STATE OF CONNECTICUT
CONNECTICUT SITING COUNCIL

IN RE: :
 :
APPLICATION OF CELLCO PARTNERSHIP : DOCKET NO. 448
D/B/A VERIZON WIRELESS FOR A :
CERTIFICATE OF ENVIRONMENTAL :
COMPATIBILITY AND PUBLIC NEED FOR :
THE CONSTRUCTION, MAINTENANCE :
AND OPERATION OF A WIRELESS :
TELECOMMUNICATIONS FACILITY AT :
831 DERBY MILFORD ROAD, ORANGE, :
CONNECTICUT : SEPTEMBER 9, 2014

RESPONSES OF CELLCO PARTNERSHIP d/b/a
VERIZON WIRELESS TO THE COUNCIL'S PRE-HEARING QUESTIONS SET 3

**Vernal Pool Analysis Map
Original Facility Layout**

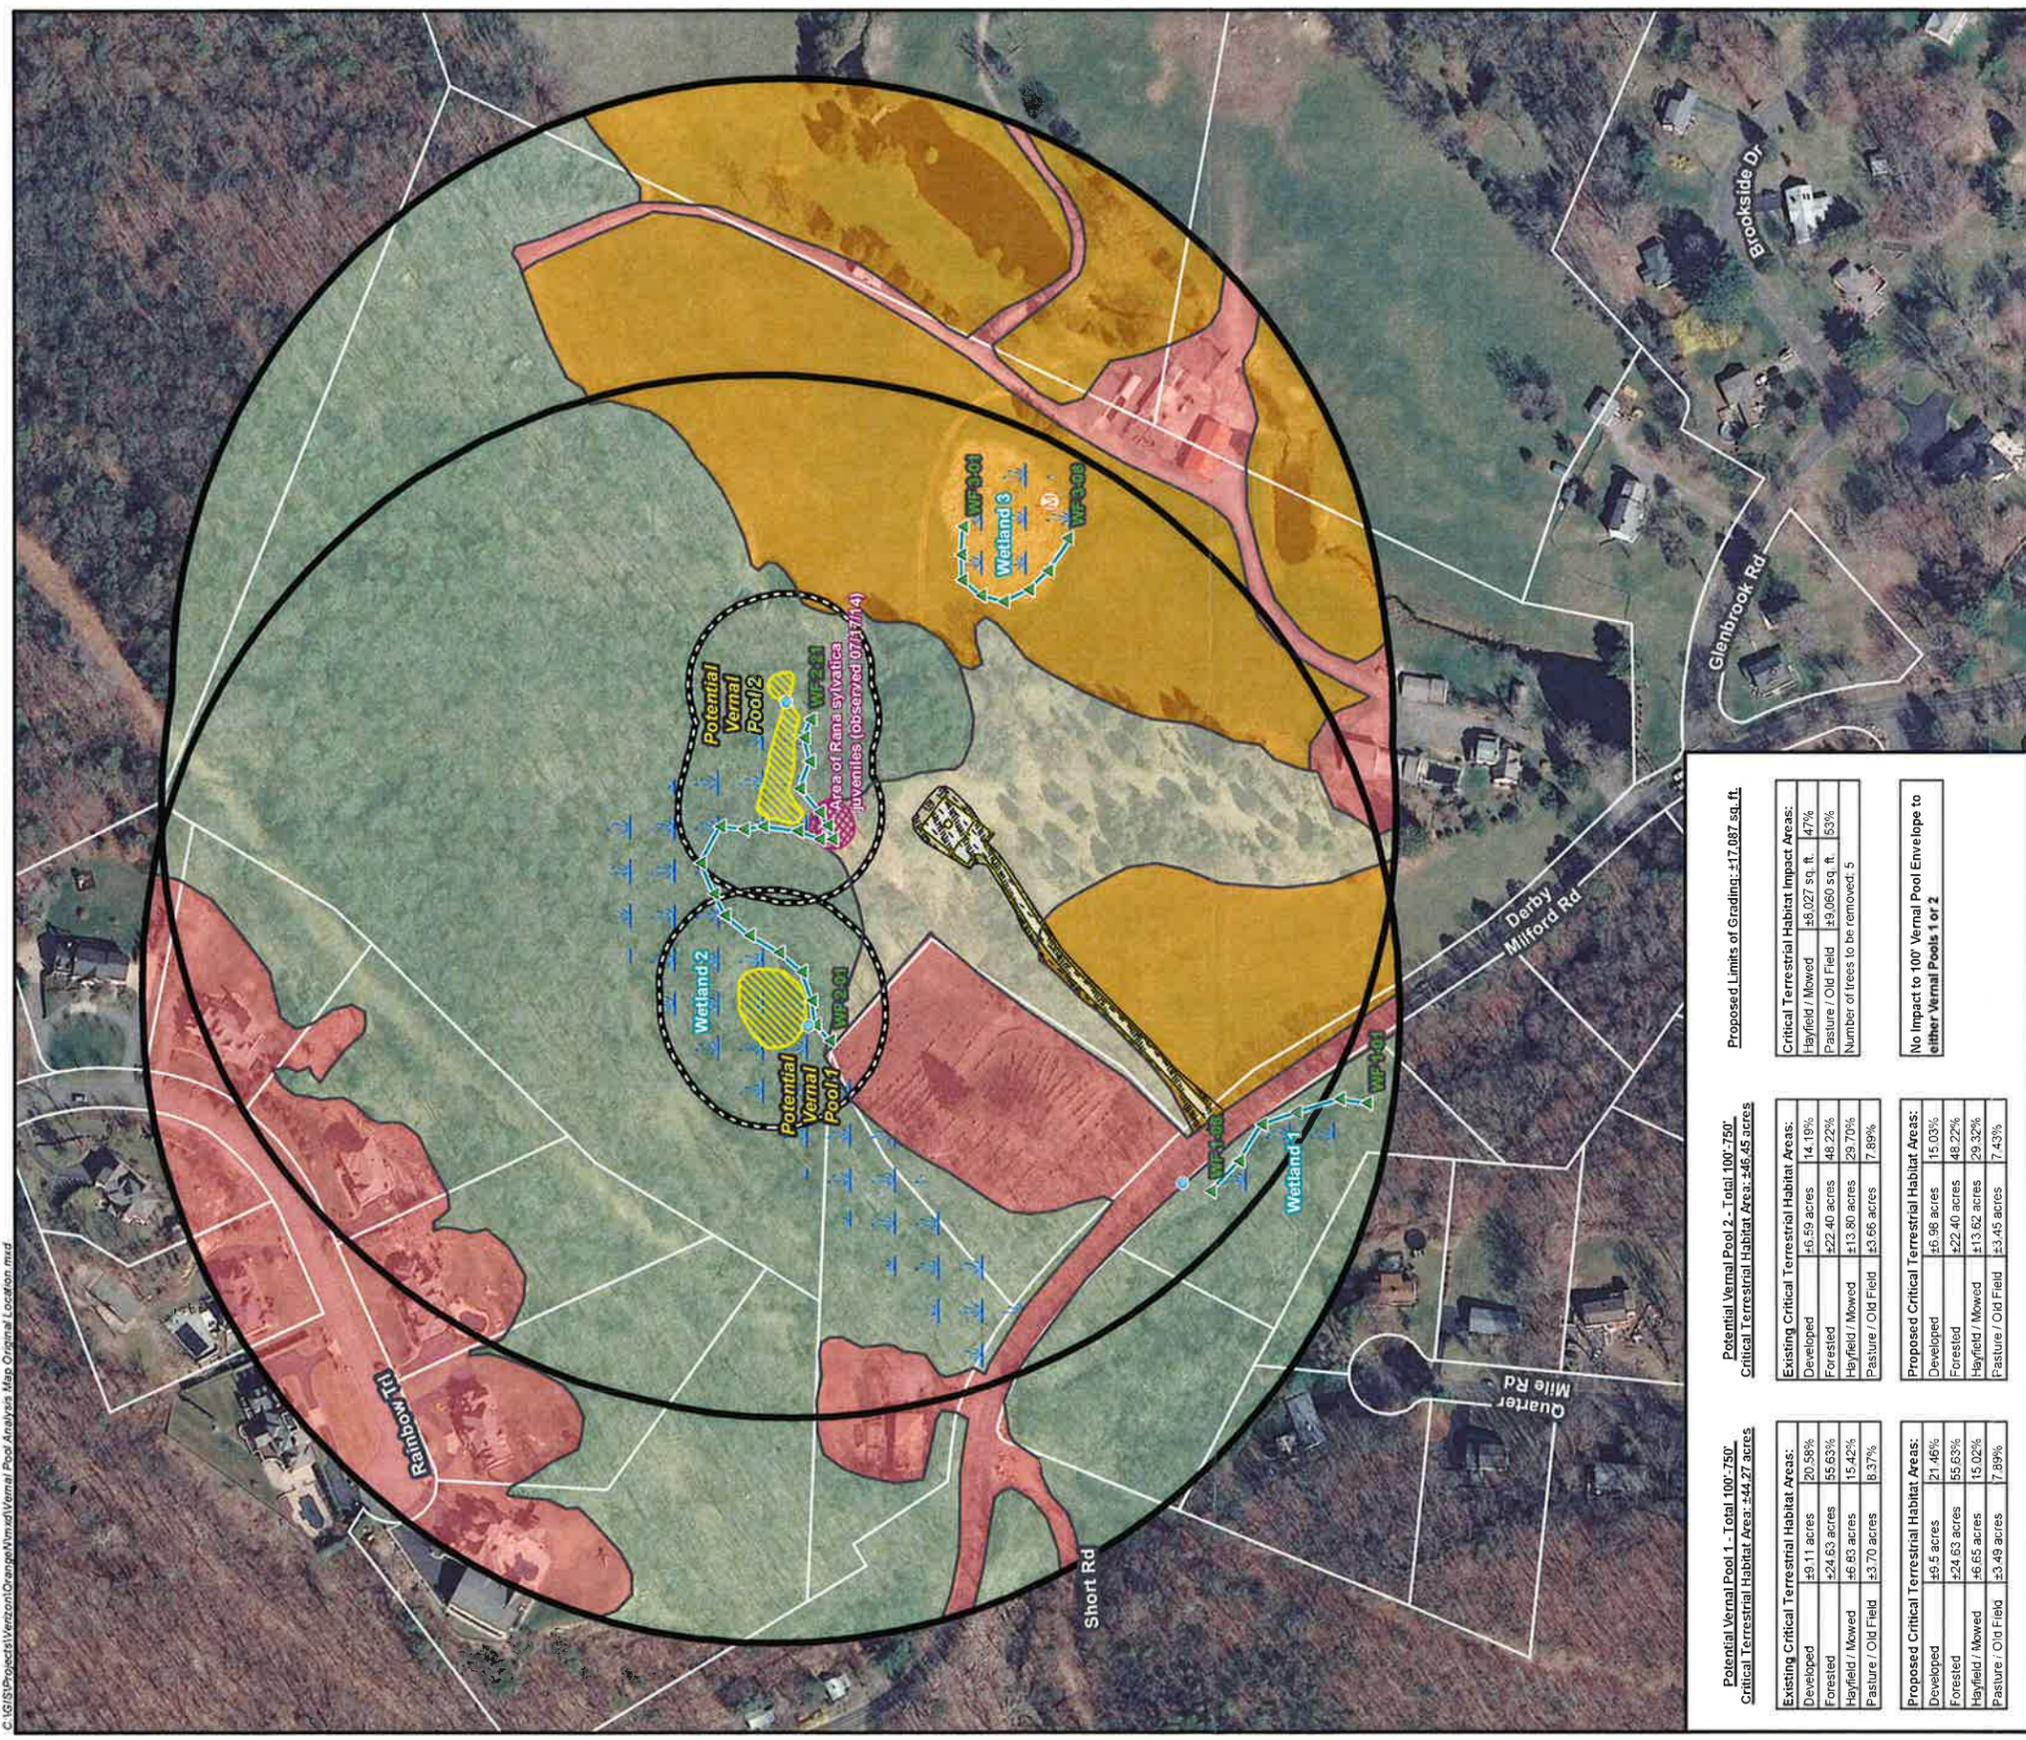
Please revise the vernal pool zonal calculations to parse out the vernal pool envelopes from the critical upland habitat zones. The current map creates single zones for 0-750'. How can one assess the percentage of development pre and post construction in the critical upland habitat zones (100-750 feet) when the envelopes (0-100 feet) have been amalgamated in those calculations?

Please indicate the location of the *Rana sylvatica* juveniles observed during the CSC's pre-hearing site visit on the Vernal Pool Map submitted in Exhibit 10, Question 2.

The original vernal pool impact analysis map mistakenly amalgamated the area calculations for the Vernal Pool Envelope (VPE, 0-100 feet) and Critical Terrestrial Habitat (CTH, 100-750 feet) conservation zones as defined in the methodology developed by Calhoun and Klemens (2002)¹. A revised vernal pool impact analysis map, titled Vernal Pool Analysis Map Original Facility Layout, has been prepared and is included in Attachment 1.

As illustrated on the Vernal Pool Analysis Map Original Facility Layout, the total area of CTH associated with pool 1, which includes land located off the 34.6 acre "Subject Parcel", is

44.27± acres, with 9.11± acres consisting of existing development (including roads, residential structures, yards and driveways). This equates to approximately 20.58% of the CTH as being already developed for pool 1.

The total area of the CTH associated with pool 2, which includes land located off the Subject Property, is 46.45± acres with 6.59± acres consisting of existing development (including roads, residential structures, yards and driveways). This equates to approximately 14.19% of the CTH as being already developed for pool 2.

The proposed facility compound and access road would result in the development of 0.39± acre of the CTH for both pools 1 and 2, which represents a de minimus increase of only 0.88% and 0.84%, respectively. The total post-construction development within the CTH of both pools remains less than 25% ($\pm 21.46\%$ and $\pm 15.03\%$ proposed condition for pools 1 and 2, respectively).

The location of the *Rana sylvatica* juveniles observed has been added to the revised Vernal Pool Analysis Maps, as provided in Attachments 1 and 3.

ATTACHMENT 2

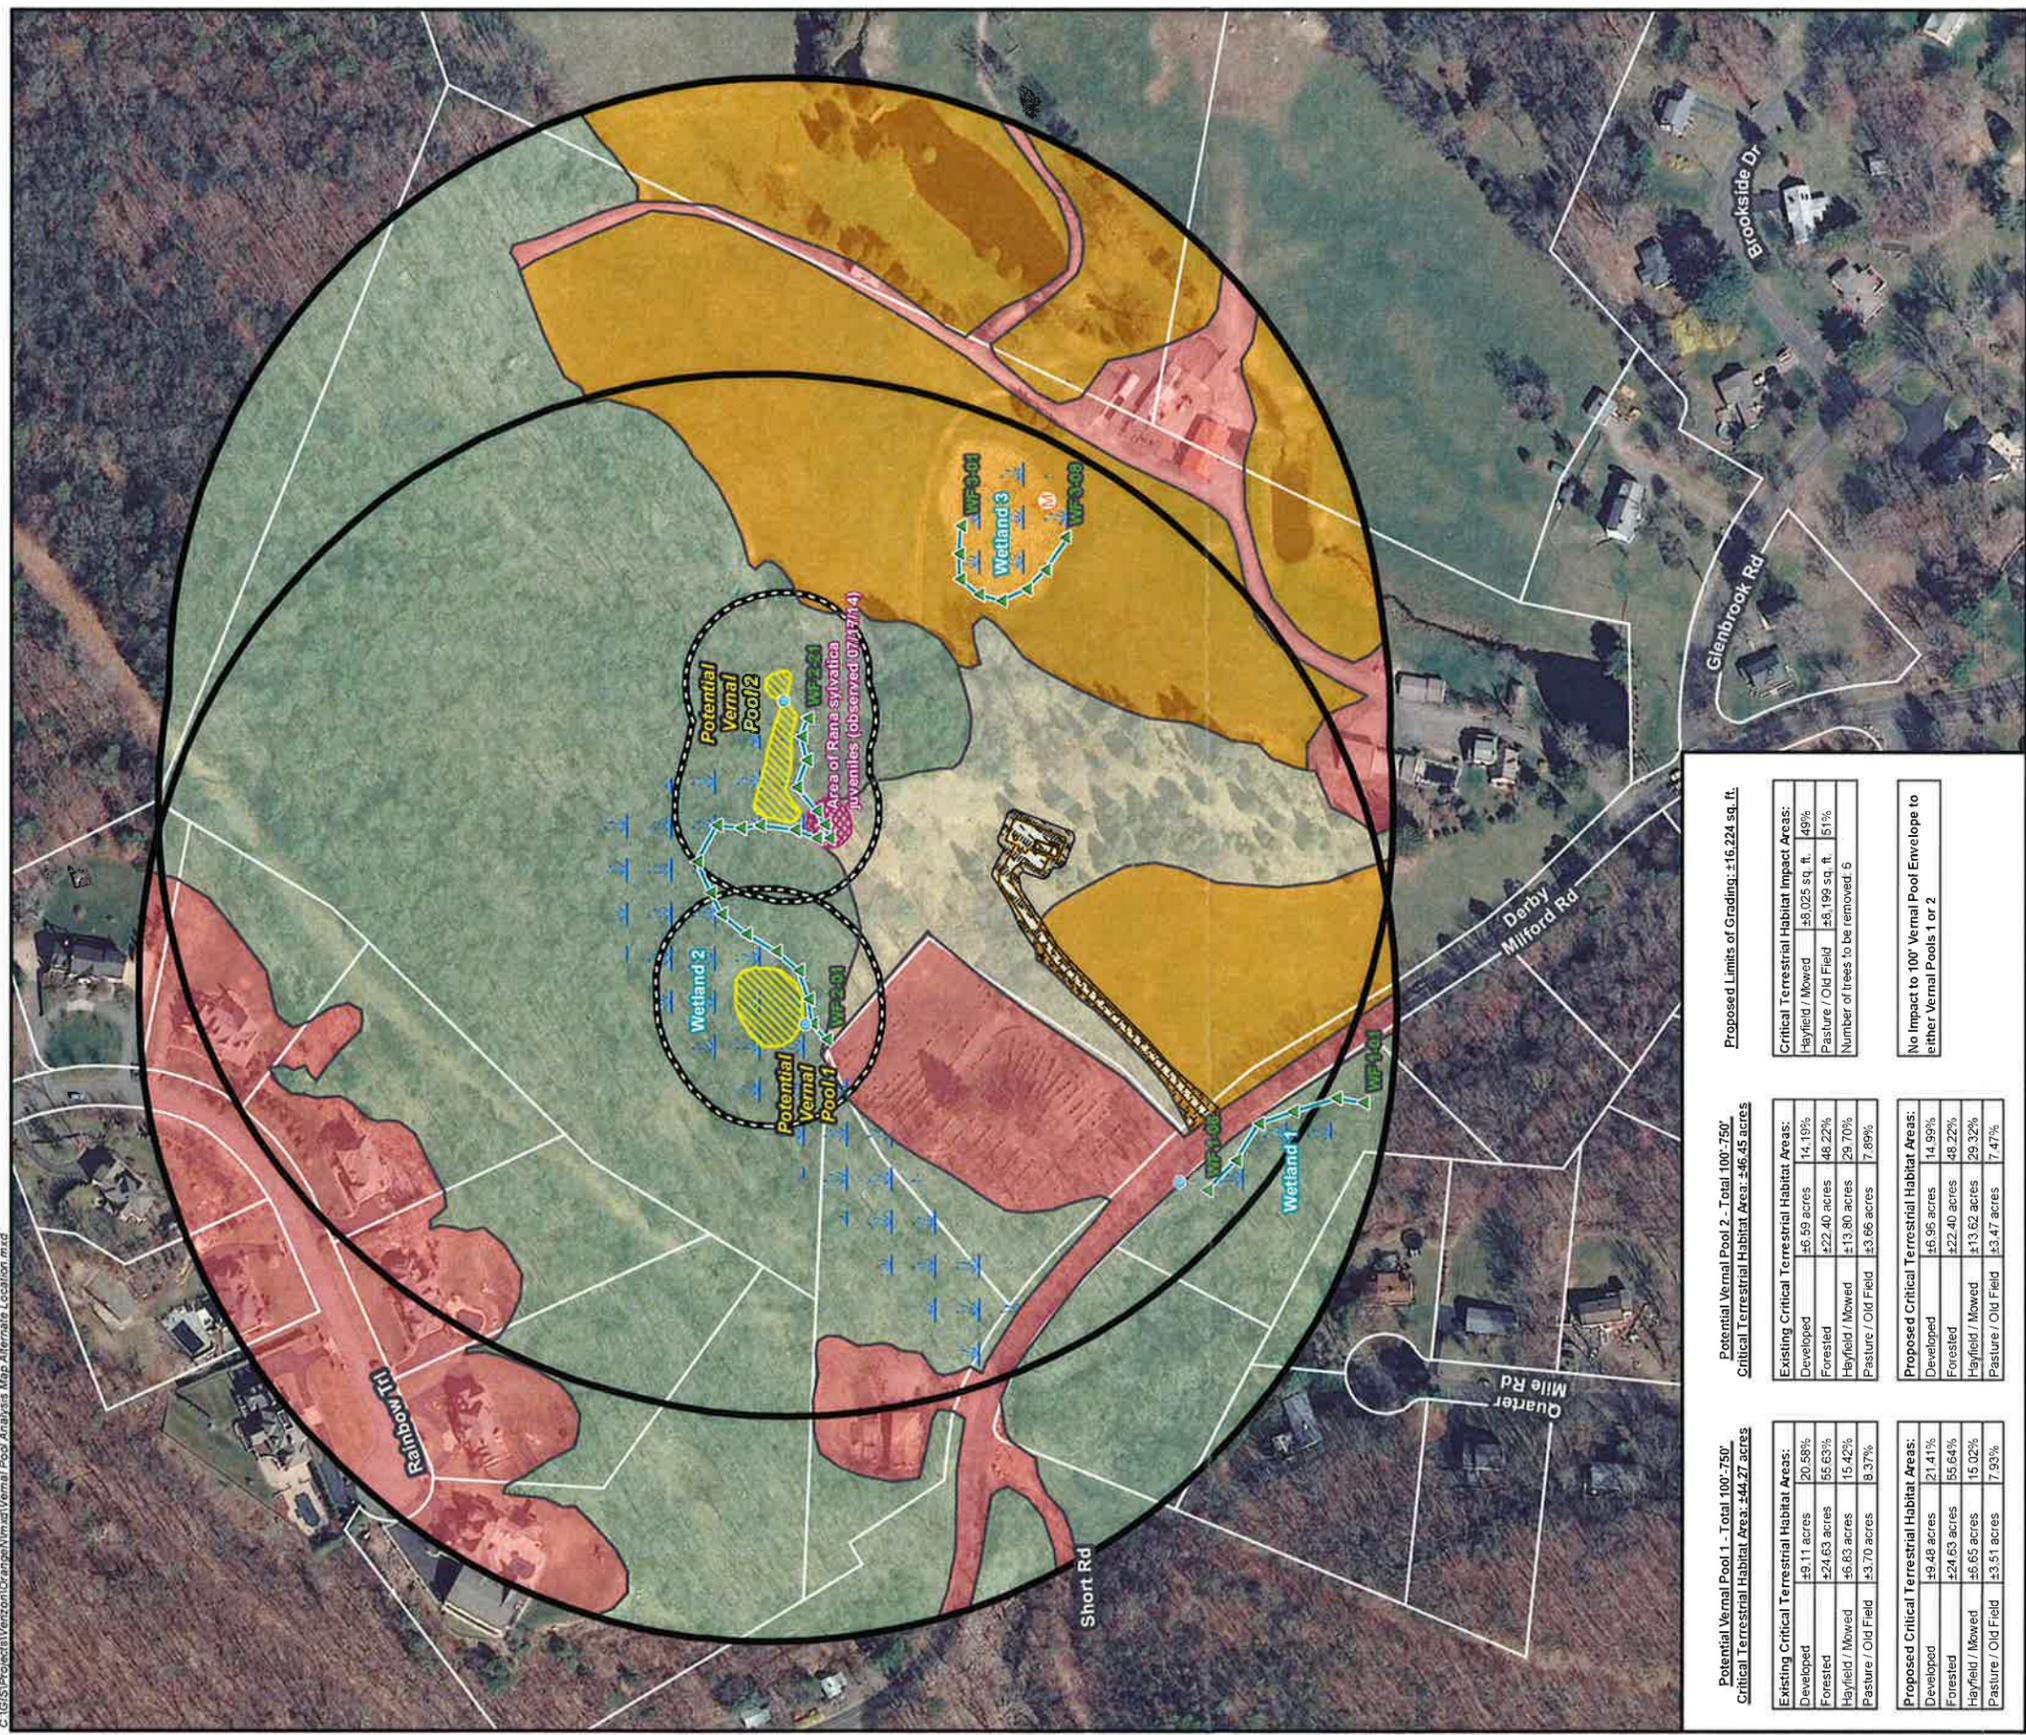
Is the lessor amenable to relocating the facility eastward on the ridge near the 150 foot topographic contour? If so, would this potential site better protect overall box turtle habitat compared to the original proposed site? Please explain.

An "Alternate Facility Location" has been proposed approximately 90 feet to the south (tower to tower distance). Please refer to the enclosed Alternate Facility Location Plan, prepared by Centek Engineering included in Attachment 2. This Alternate Facility Location results in greater distance separation from the nearest wetland area (Wetland 2); ± 108 feet from compound corner for the original site to nearest wetland (wetland flag WF 2-15) compared to ± 218 feet from compound corner for the alternate site to this same wetland location. The Alternate Facility Location is also located entirely outside of the local watershed that feeds Wetland 2 with surface drainage associated with this location flowing to the west/southwest into the mowed hayfield.

The proposed Alternate Facility Location (Attachment 2) is in fact more protective of box turtle habitat. By moving the tower to the south, the proposed disturbance is located further from

the wetland-upland interface, increasing the separation by more than 100 feet compared to the Original Facility Location. Additionally, the Alternate Facility Location results in less fragmentation of the old field/pasture habitat due to the fact that the tower would be located directly adjacent to an existing hayfield that is regularly mowed and considered a low value habitat, as opposed to within the center of the old field/pasture habitat.

Mt. St. Peter Cemetery

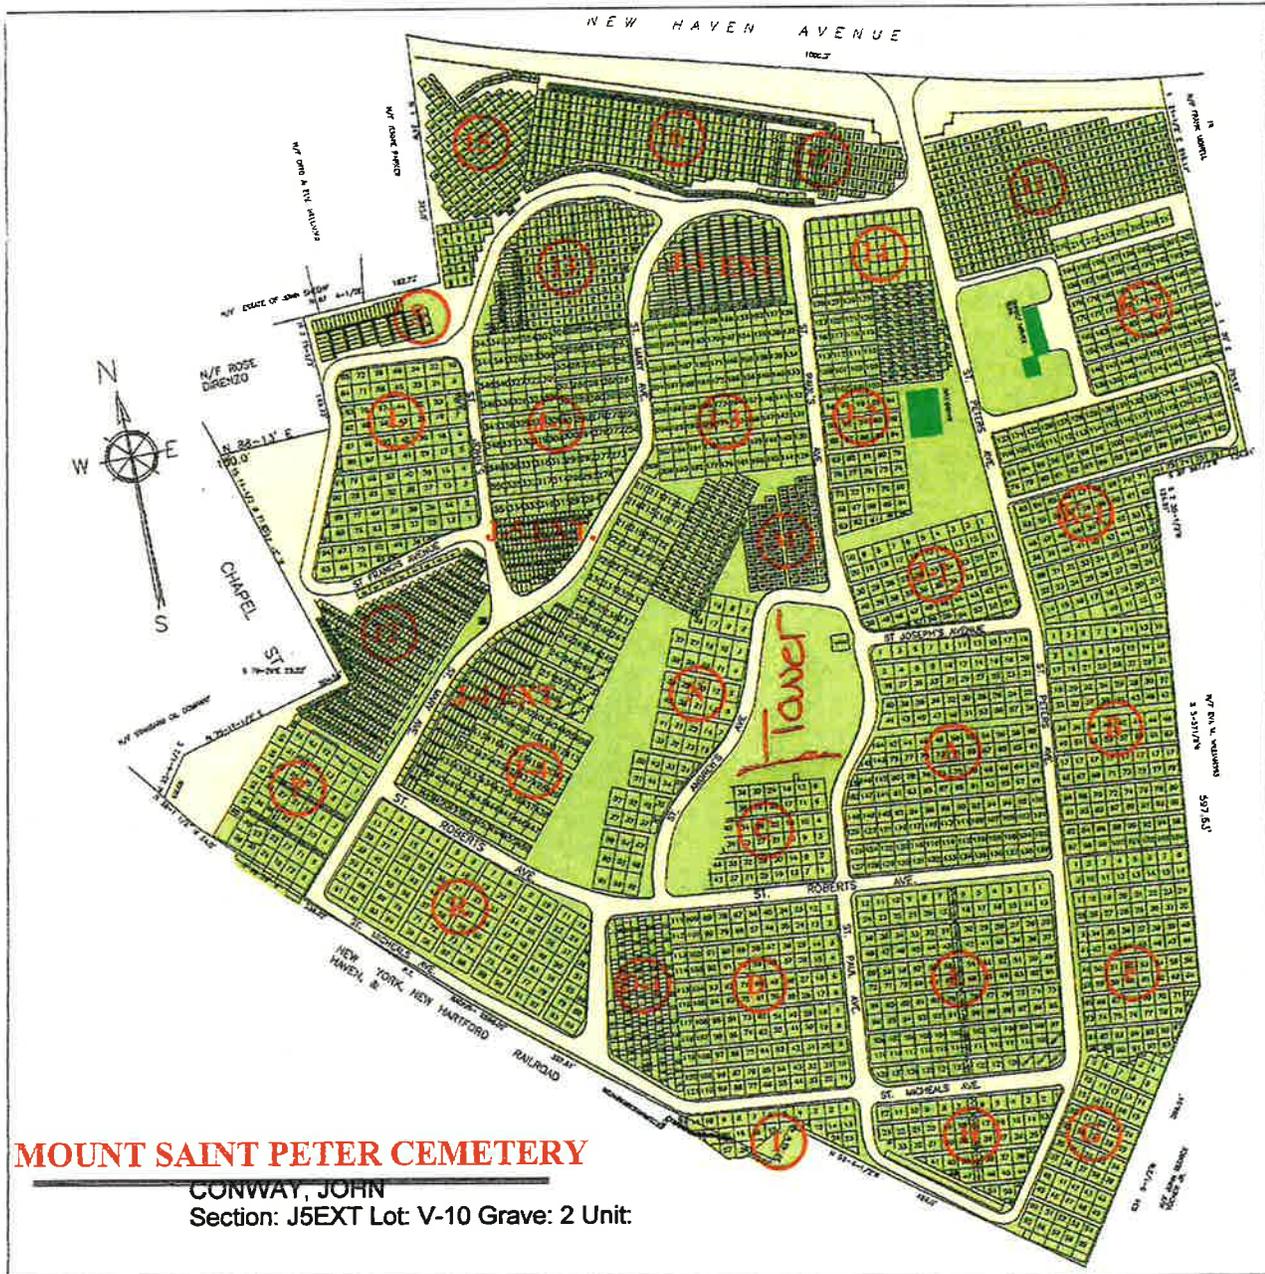
If a site is viable at the Mount Saint Peter's Cemetery in Derby, would it supplant the need for both the Docket 448 site and the 111 New Haven Avenue Derby site? Please explain.

Notwithstanding this prohibition, Cellco reached out to the CCA and on August 20, 2014, members of Cellco's project team conducted a site visit at the Mount Saint Peter's Cemetery. Prior to this site visit, the CCA sent Cellco a map of the Mount Saint Peter's Cemetery, identifying a location, marked "Tower" near the center of the cemetery. (See Attachment 5). Kevin Gerckens, a representative of the CCA met with members of Cellco's project team at the cemetery. Also in attendance was Counsel for the intervenors Albert Subbloie, Jacqueline Barbara, Glenn Macinnes and Jill Macinnes. All parties and intervenors in Docket No. 448 were notified of the site visit.

Mr. Gerckens described two locations on the Mount Saint Peter's Cemetery property that he considered potentially available for development of a tower site. The first location presented is an approximately 14,500 square foot portion of the cemetery parcel, located about 300 feet southwest of the cemetery's administrative buildings ("Option 1"). This is the same area labeled "Tower" on Attachment 5. The Option 1 location is surrounded by grave sites, internal access driveways and large mature evergreen and deciduous trees ranging in height from approximately 65 to 80 feet. Large bedrock outcroppings are visible throughout this area. The Option 1 location maintains a ground elevation ("GE") of approximately 120 feet above mean sea level ("AMSL"), 14 feet lower than the GE at the proposed Orange North cell site (134' AMSL). The Option 1 location is approximately 0.7 miles west of the proposed Orange North cell site and approximately 0.9 miles west of the center of the Orange North search area.
